Y1A, Y1B, Y1C- High-Voltage (HV) Battery Measurements during HV Battery Repair

Models	Model Year	Model Type	VIN Range	Vehicle-Specific Equipment
Taycan	All	Y1A, Y1B, Y1C	All	N/A

Revision	Release Date	Changes
0	November 6, 2025	<ul style="list-style-type: none"> ▪ Original document
1	November 11, 2025	<ul style="list-style-type: none"> ▪ Update to <i>Figure 2</i> ▪ Update to <i>IR Testing Pass/Fail Criteria</i> section on page 8
2	December 2, 2025	<ul style="list-style-type: none"> ▪ Update to <i>General DST Procedure Updates</i> section ▪ Update to <i>IR Testing Pass/Fail Criteria</i> section failure threshold <ul style="list-style-type: none"> ▪ Update to Model Years

Figure 1 - 28-module HV Battery measurement points

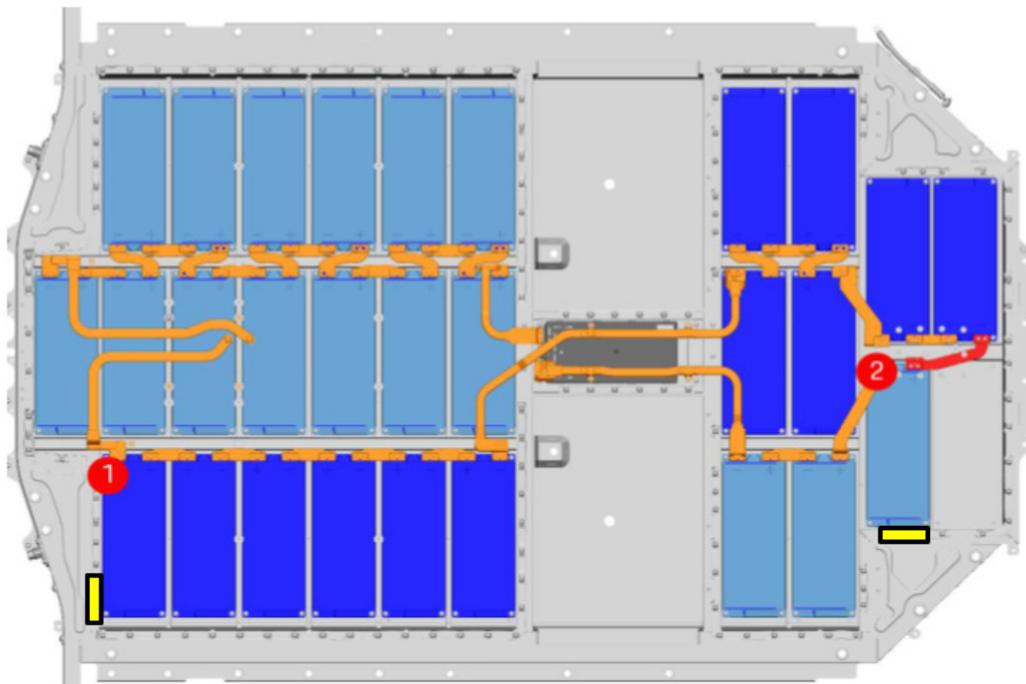
DST Procedure for 28-module Taycan Battery Pack (Figure 1)

- Only two DSTs are to be performed on a 28-module battery pack during repair.
- The busbar indicated in red must be removed prior to measurements at either point.

- Perform an IR test at points 1 and 2 before the DST at those points.
- Perform a DST only at points 1 and 2 shown below for each repair scope.
- The yellow boxes in *Figure 1* designate the sections of laser clean surface (silver stripe) to contact using the negative probe to ground the dielectric strength tester. This method ensures consistency in testing.

- Also perform IR tests at points 1 and 2 after a DST, with the negative probe also on the surface designated by the yellow boxes.
- If the DST at measurement point 1 fails, remove busbars and CMC connections from each module shaded in dark blue for further IR testing as described in the following *Updated IR Measurement Procedure* sections.

- If the DST at measurement point 2 fails, remove busbars and CMC connections from each module shaded in light blue module for further IR testing as described in the following *Updated IR Measurement Procedure* sections.

- EXAMPLE: Point 1 passes DST and point 2 fails.
 - Perform IR tests on each light blue module in the failing section (In this example, section 2). No additional work is required for the passing modules in section 1.

Figure 2 - 33-module HV Battery measurement points

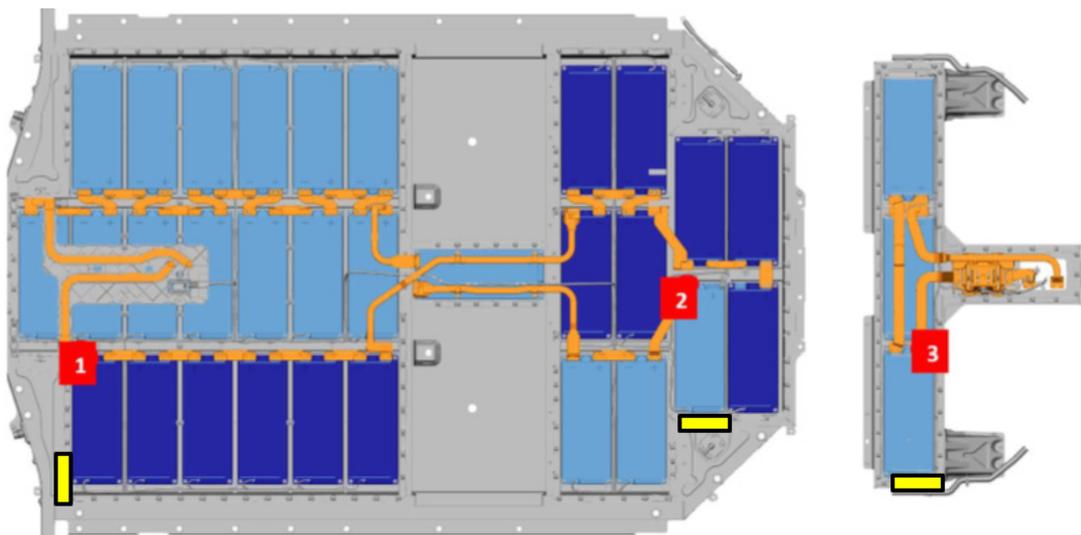
DST Procedure for 33-module Taycan Battery Pack (Figure 2)

- Only a total of three or four DST's are to be performed on the 33-module battery pack during repair, depending on scope.
 - ▷ Perform a DST only at points 1, 2, and 3 for any repair scope involving the lower-level modules.

- ▷ Repair scopes in only the upper "T" section require an initial DST (in addition to the points in *figure 2*) at the mid-pack fuse as shown in step 3.9.3 of Safety test after assembly work on the high-voltage battery with 33 modules in WM 270803A5. Only proceed with removing lower lid if this initial DST fails.

- If removed, the upper "T" Section should be placed aside on a VAS 6762/44 Insulating mat during testing.
- Perform an IR test at points 1, 2 and 3 before the DST at those points.

- The yellow boxes in *Figure 2* designate the section of laser clean surface (silver stripe) to contact using the negative probe to ground the dielectric strength tester. If performing a DST on the mid-pack fuse, use the location on the upper "T" section to ground the negative probe.

- Perform IR tests at points 1, 2, and 3 after a DST, with the negative probe also on the surface designated by the yellow boxes.
- If the DST at measurement point 1 fails, remove busbars and CMC connections from each module shaded in dark blue for further IR testing as described in the following *Updated IR Measurement Procedure* sections.

- If the DST at measurement point 2 fails, remove busbars and CMC connections from each module shaded in light blue for further IR testing as described in the following *Updated IR Measurement Procedure* sections.

- If the DST at measurement point 3 fails, remove busbars and CMC connections from each module in the upper "T" section for further IR testing as described in the following *Updated IR Measurement Procedure* sections.

- EXAMPLE: It is possible for battery to have point 1 pass, point 2 pass, and point 3 fail the DST. It would then only be required to perform further IR tests on each module in the upper "T" section. No additional work would be required for the passing lower sections.

Figure 3 - IR Test at Positive Terminal

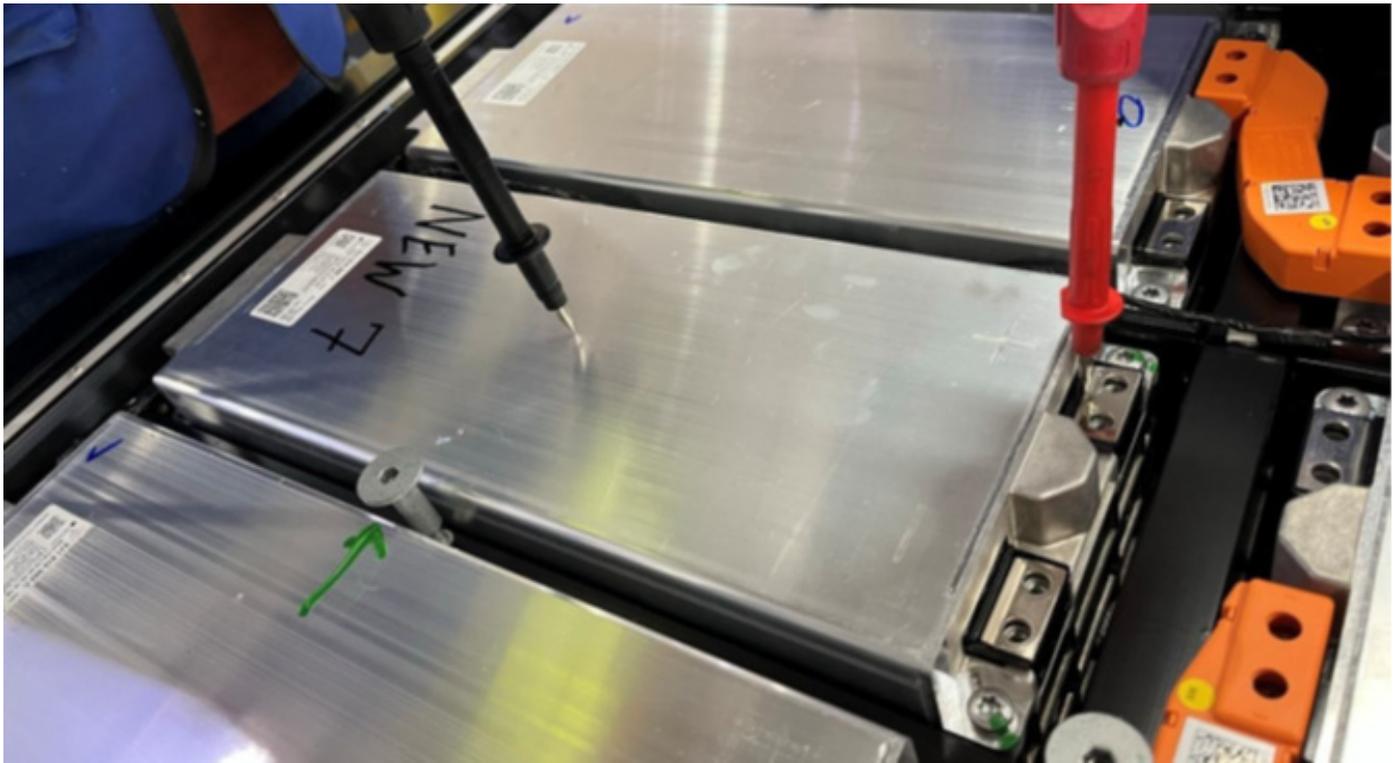
Module IR Testing Procedure: Positive Terminal (Figure 3)

- Place the red probe at the edge closest to the black plastic surrounding the terminal to avoid scratching the conductive surface.
 - CAUTION: pay attention to the angle of the red probe in this case. Avoid contact with the side of the probe and the edge of the module housing. Use a plastic probe cap to expose only the tip of the probe if available.
- Maintain contact with the black probe to the module case in the center. Ensure that the module casing surface is clean at the point of contact.
- The equipotential bonding cable is not suitable as a ground point during this test. Use both straight probes directly on the module to isolate conductive influences.

Figure 4 - IR Test at Negative Terminal

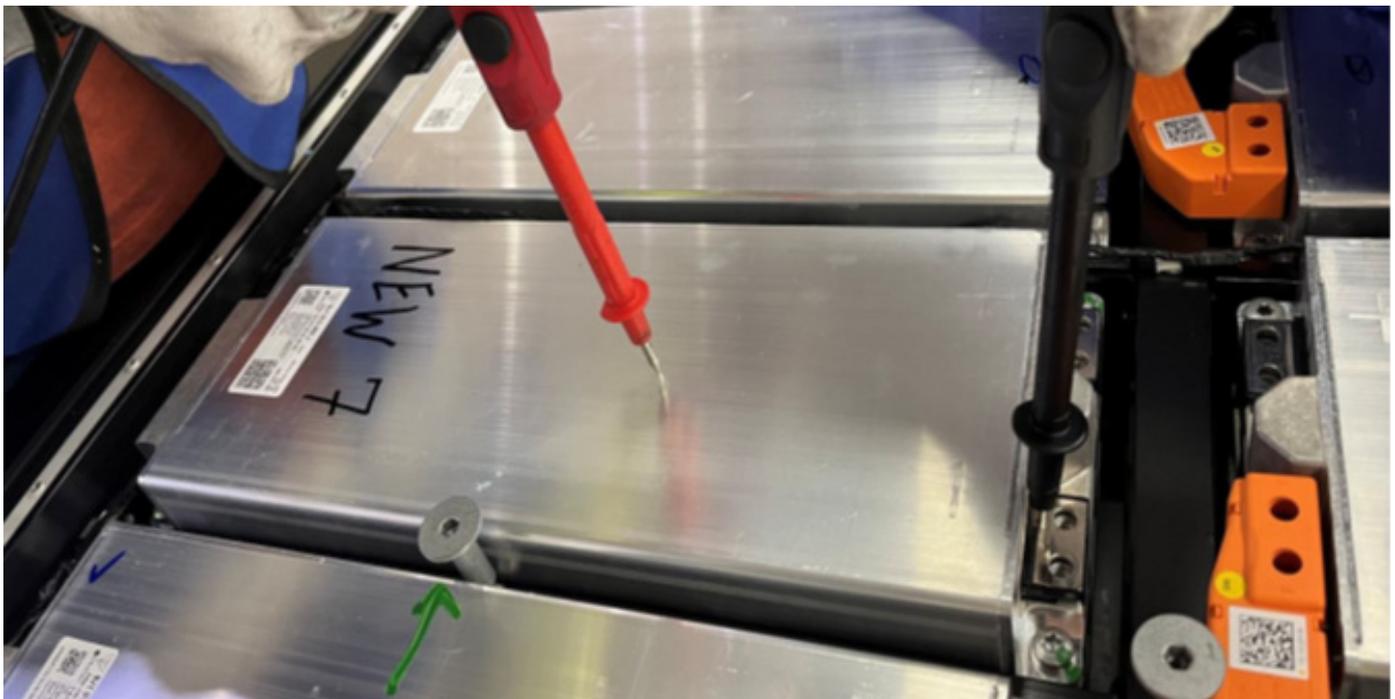
Module IR Testing Procedure: Negative Terminal (Figure 4)

- Place the black probe at the edge closest to the black plastic on the terminal to avoid scratching the conductive surface.
 - CAUTION: Pay attention to the angle of the black probe in this case. Avoid contact with the side of the probe and the edge of the module housing. Use a plastic probe cap to expose only the tip of the probe if available.
- Maintain contact with the red probe to the module case in the center. Ensure that the module casing surface is clean at the point of contact.
- The equipotential bonding cable is not suitable as a ground point during this test. Use both straight probes directly on the module to isolate conductive influences.

Figure 5 - Insulation resistance measurement in PIWIS Tester

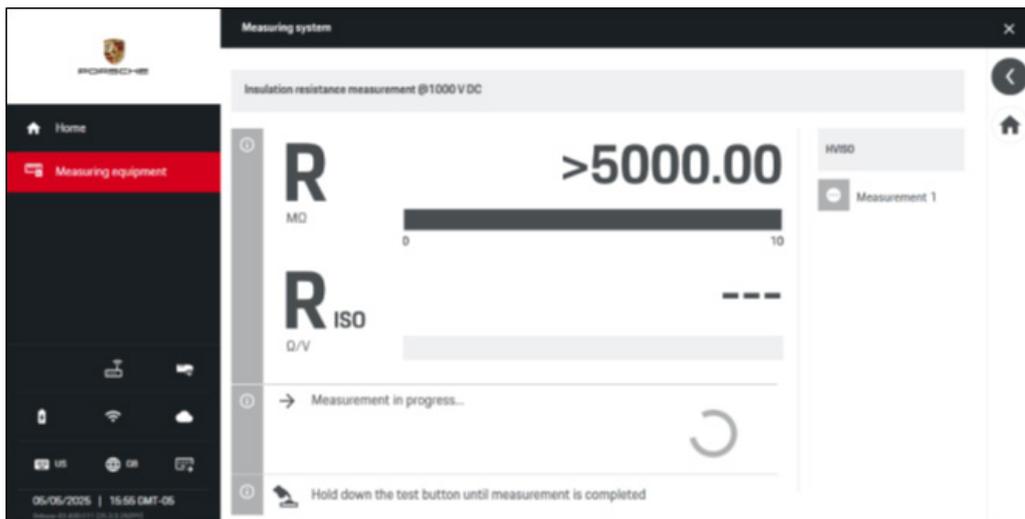
IR Testing Pass/Fail Criteria (Figure 5)

- Shown below is an example of passing test result of >5000 MΩ. This is the reading displayed when IR measures above the 500 MΩ measuring threshold.
- IR values between 200 MΩ and 500 MΩ are also acceptable for the second measurement on a terminal.
- If the first IR test on either module terminal fails, but the second one passes, the module is okay and should not be replaced.
- If any second terminal IR test shows a number below 200 MΩ, this is considered a failure.
- If IR is below the measurement threshold, the IR test won't complete in the measurement equipment display. If the IR test fails to produce a value after multiple attempts on any module terminal, replace it.
- Document any failures in the "Module insulation Resistance Template" Excel file attachment and attach to the PRMS Ticket and repair PCSS entry.
